Interactive comment on “Time difference of arrival estimation of microseismic signals based on alpha-stable distribution” by Rui-Sheng Jia et al.

Received and published: 21 February 2018

Fig. 3.

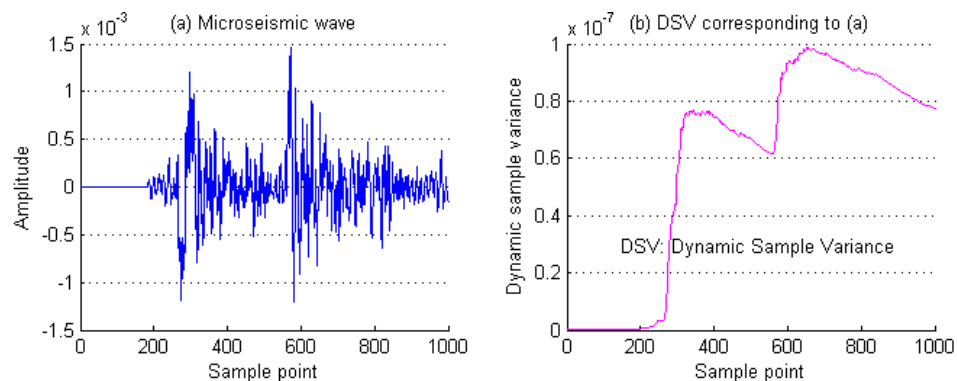
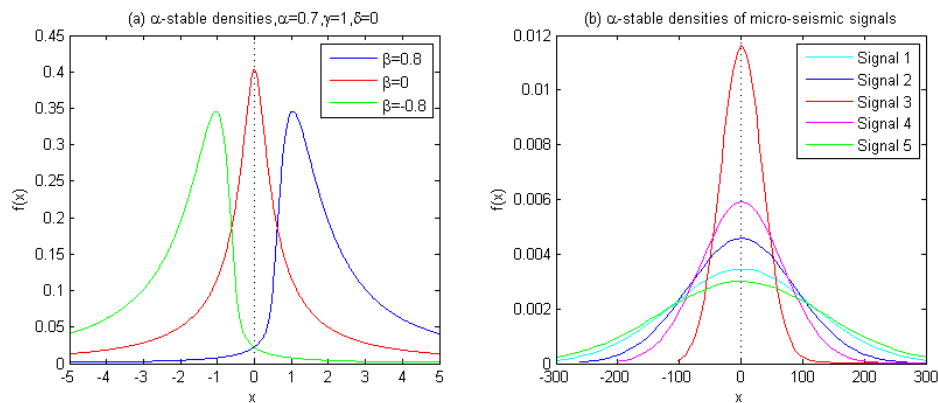
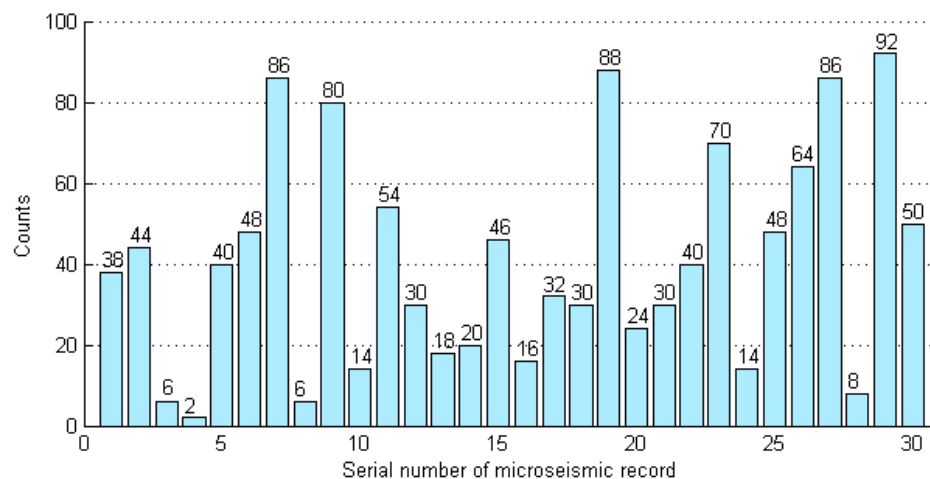
Q5. In Fig3(a), the energy of P wave is larger than the energy of S wave. But in most field microseismic data, the energy of S wave is larger than the energy of P wave, so I think your measured microseismic signal is not representative.

A5: It is really true as Reviewer suggested that our measured microseismic signal is not representative, We have chosed a typical microseismic signal and redrew Fig. 3. For more detail , see Fig. 3 in P17.

Fig. 6.

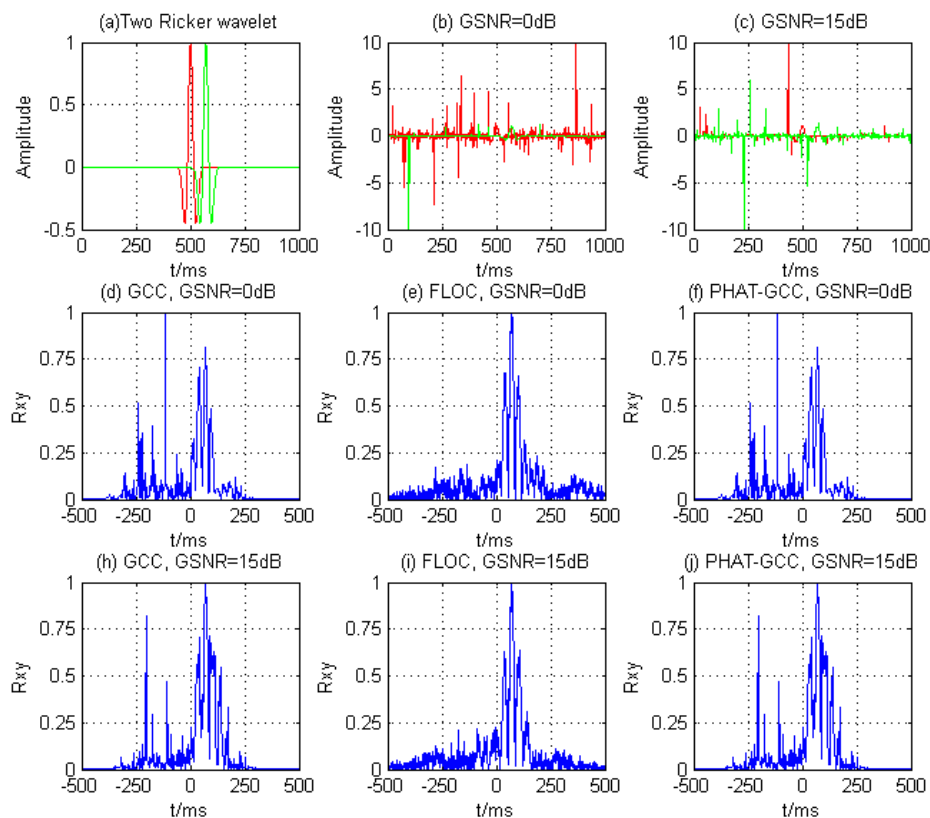
Q6. In Fig. 6, your method is just compared with one conventional method. I think this is not enough, your method should be compared with two conventional methods at least so that the advantages of your method are more persuasive.

A6: Considering the Reviewer's suggestion, we have added PHAT-GCC method to be compared. See P18.
